# Access Compliance Report

## Public Rights-of-Way

### (Curb Ramps)

Intersection ID: 14474	Main Street: BROOKHILL_RD	Cross Street: S_TRYON_ST	Location: NW
ADA ID: 9FB8BCAB7958	Ramp Type: Perp	Initial Pass/Fail: Fail	Overall Compliance: No
Severity Score: 10			
Codes/Mitigation Info/Possible Solution		Field Measurements/Component Compliance

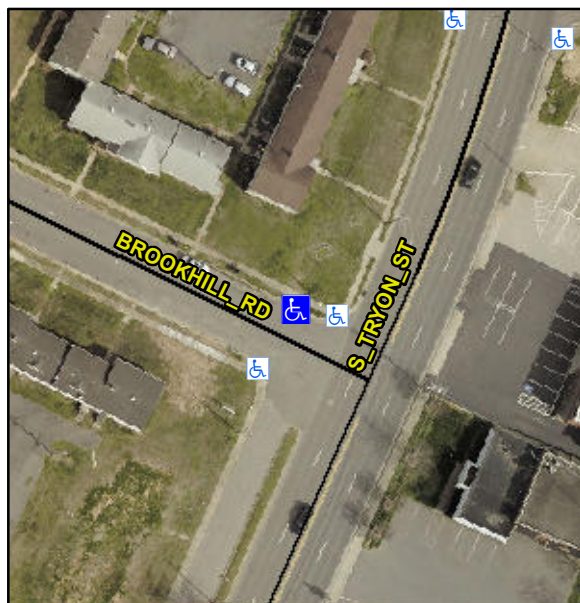
**Not Found, R304.5.1, R304.5.3**

Compliance	Description	Data	Compliance	Description	Data
N/A	Ramp Length (in)	39.0	Yes	Ramp Slope (%)	5.2
No	Ramp Width (in)	47.0	No	Ramp XSlope (%)	2.2
N/A	Flare Type LT	N/A	N/A	Flare Type RT	N/A
N/A	Flare Slope LT (%)	N/A	N/A	Flare Slope RT (%)	N/A
N/A	Flare Traversable LT?	N/A	N/A	Flare Traversable RT?	N/A
N/A	Landing Length (in)	N/A	N/A	DWS Provided?	N/A
N/A	Landing Width (in)	N/A	N/A	DWS Contrast?	N/A
N/A	Landing Slope (%)	N/A	N/A	DWS Length (in)	N/A
N/A	Landing X Slope (%)	N/A	N/A	DWS Full Width?	N/A
N/A	Landing Curb? (Y/N)	N/A	N/A	DWS Offset (in)	N/A
N/A	Shared Landing?	N/A			
N/A	Gutter Ponding?	N/A	N/A	Gutter Slope (%)	N/A
N/A	Gutter Lip Ht (in)	N/A	N/A	Gutter X Slope (%)	N/A
N/A	Painted X Walk1?	No	N/A	Painted X Walk2?	N/A
	X Walk 1 Direction	To SW		X Walk 2 Direction	N/A
N/A	X Walk 1 Width (in)	N/A	N/A	X Walk 2 Width (in)	N/A
	X Walk 1 Slope (%)	6.4		X Walk 2 Slope (%)	N/A
	X Walk 1 X Slope (%)	2.3		X Walk 2 X Slope (%)	N/A

**Remove & Replace Entire Ramp.**
